CITY OF BLOOMINGTON

ROAD PLANS
ROCKPORT ROAD RECONSTRUCTION
PHASE 2

ROCKPORT ROAD RECONSTRUCTION FROM APPROXIMATELY 270 FEET NORTH OF RALSTON DR TO APPROXIMATELY 150 FEET NORTH OF COUNTRYSIDE LN, LOCATED IN SECTION 8, T8N, R1W, PERRY TOWNSHIP, MONROE COUNTY, INDIANA

PLAN & PROFILE
ROCKPORT ROAD

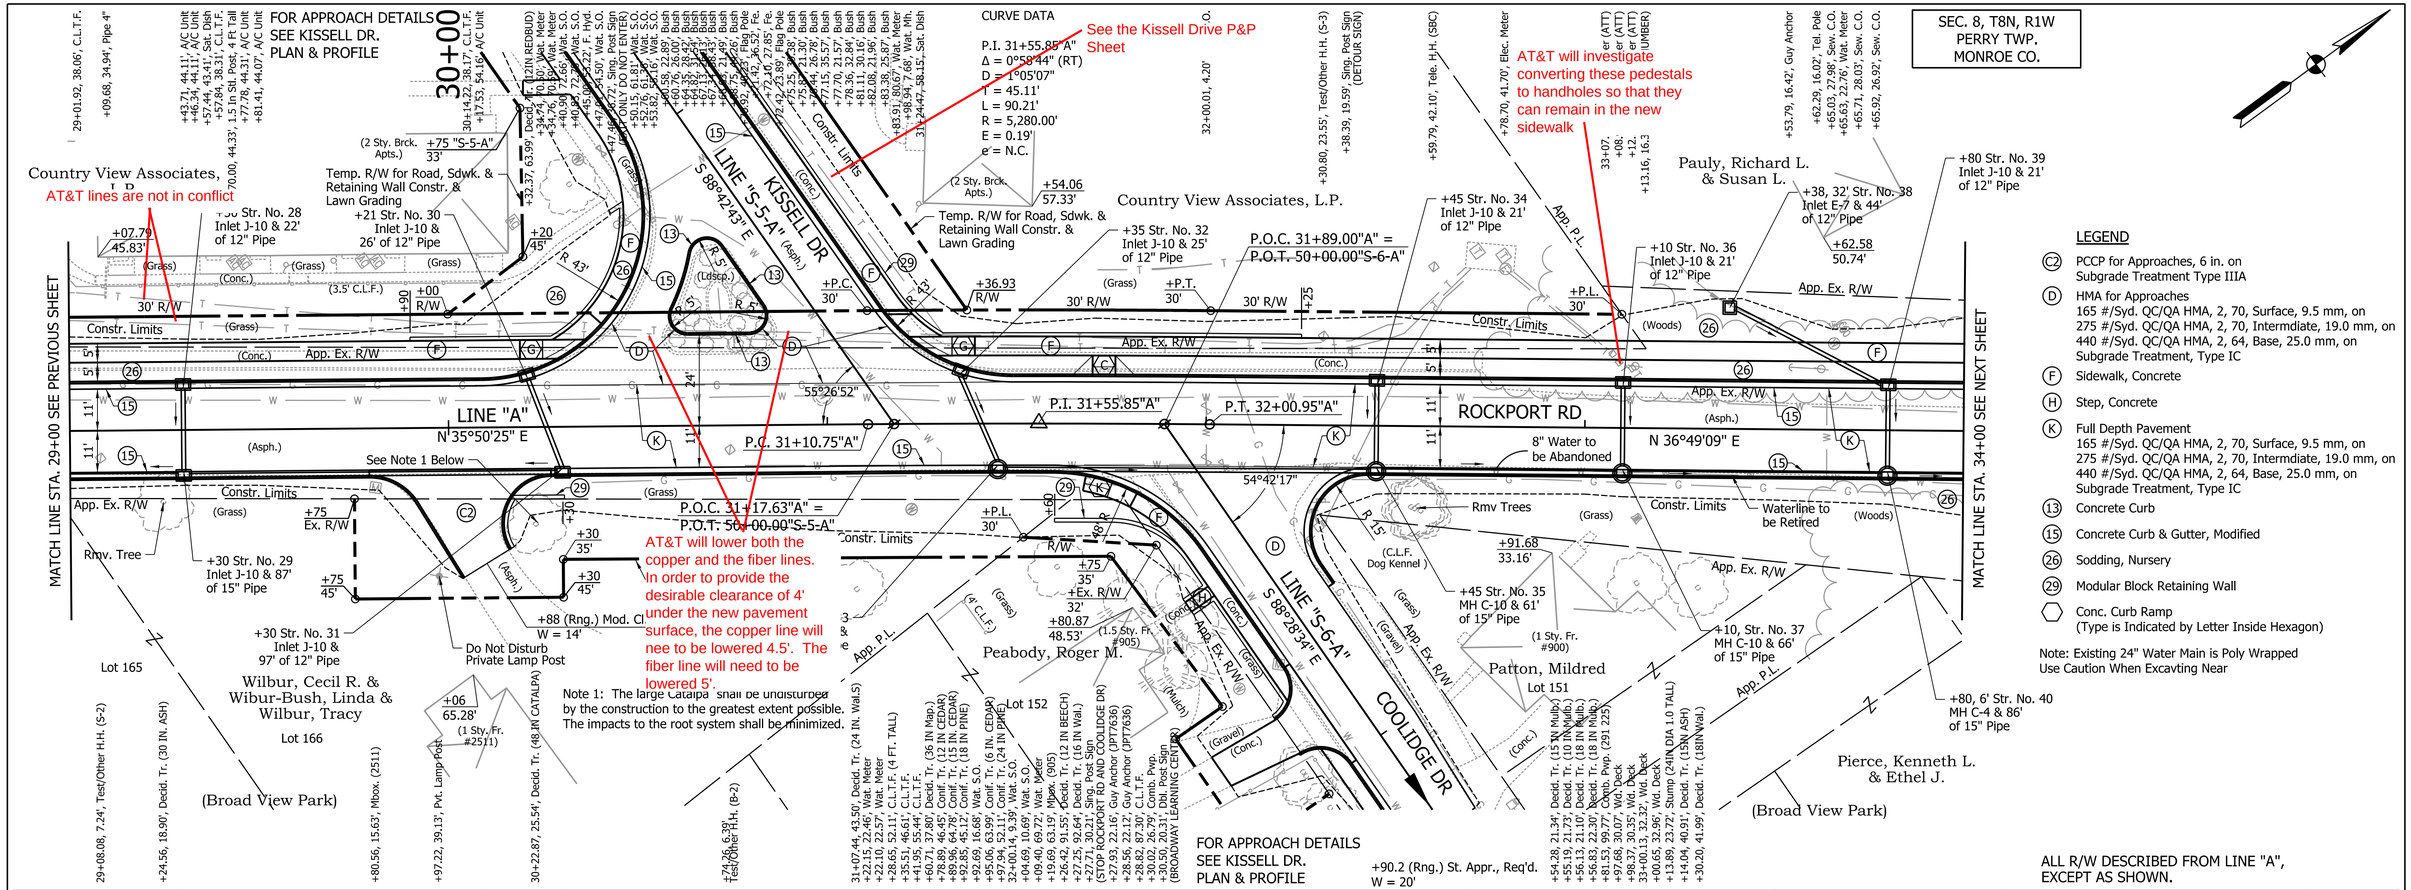
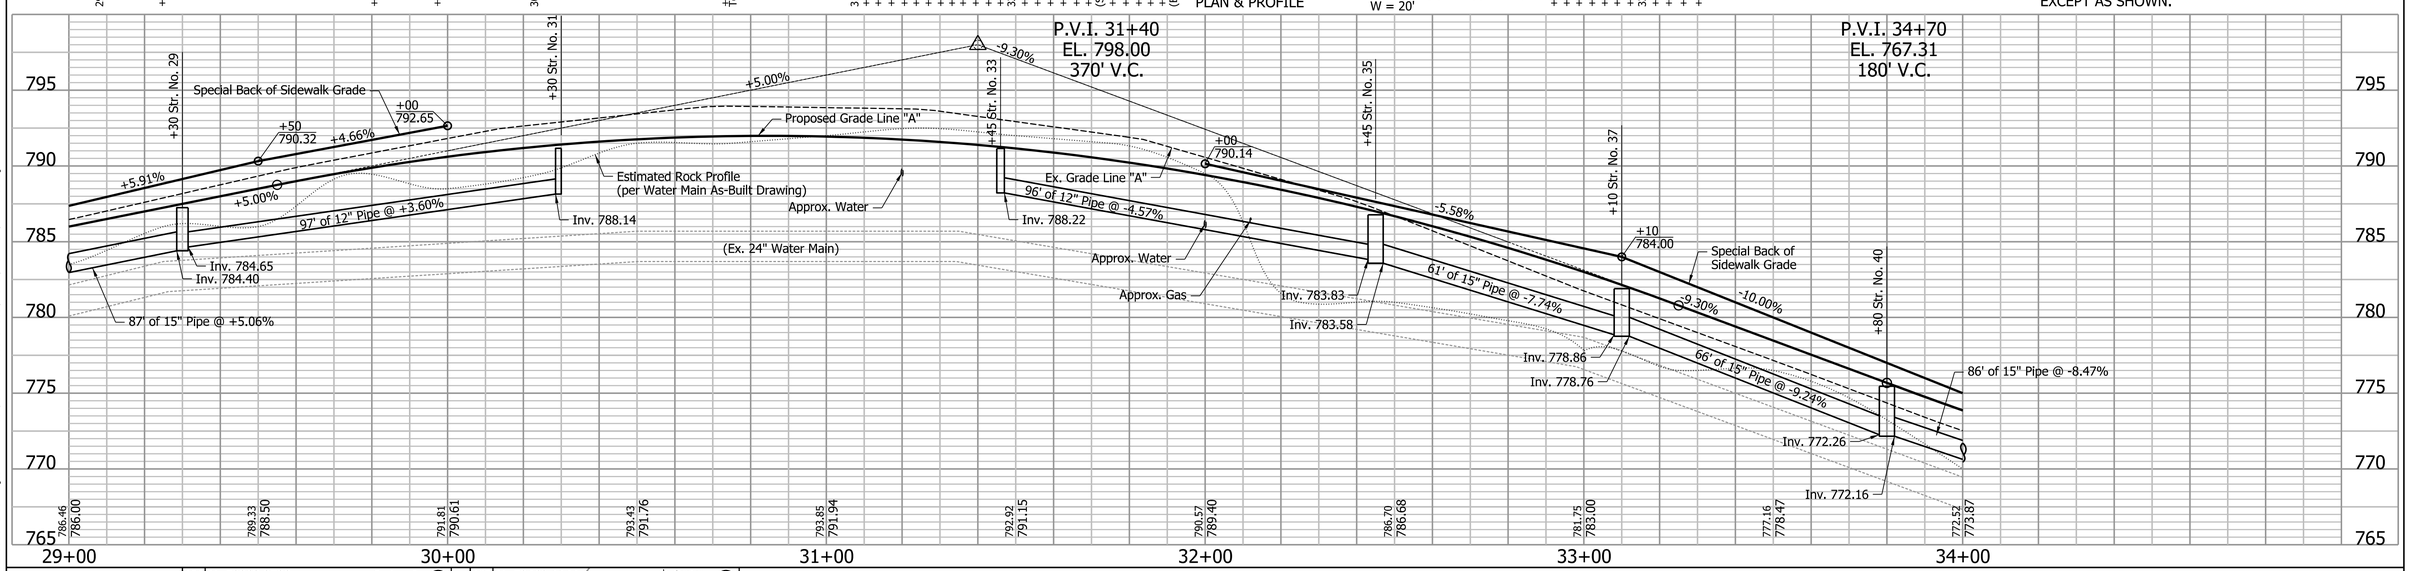
AT&T will investigate converting these pedestals to handholes so that they can remain in the new sidewalk

AT&T will lower both the copper and the fiber lines. In order to provide the desirable clearance of 4' under the new pavement surface, the copper line will nee to be lowered 4.5'. The fiber line will need to be lowered 5'.

AT&T lines are not in conflict

Note 1: The large catalpa shall be undisturbed by the construction to the greatest extent possible. The impacts to the root system shall be minimized.
